Technical Service Bulletin

Number: PC13-006

Subject: Cooler Mounts on ZX75 and ZX125 Excavators (Information Only)

**Cooler Mounts part#
part# 17762188**

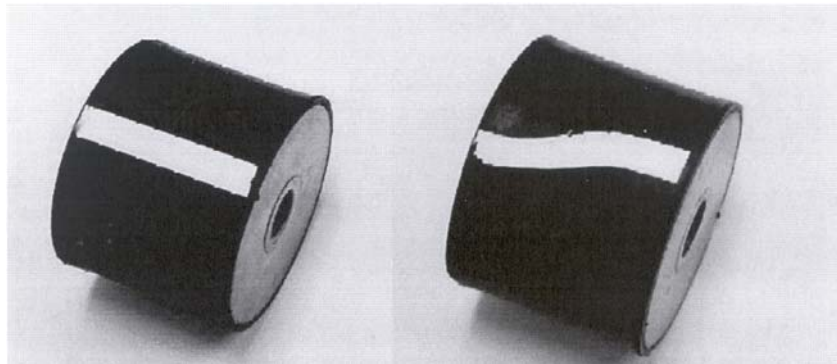
During installation, the cooler mounts may become twisted and cause premature failure. To prevent this from happening, make a line lengthwise on the mount with a straight edge prior to installation. Install the mount. Use a strap wrench to hold the mount while tightening the fasteners. After tightening both sides of the mount, the line you made on the mount should be straight.

Correct

Wrong
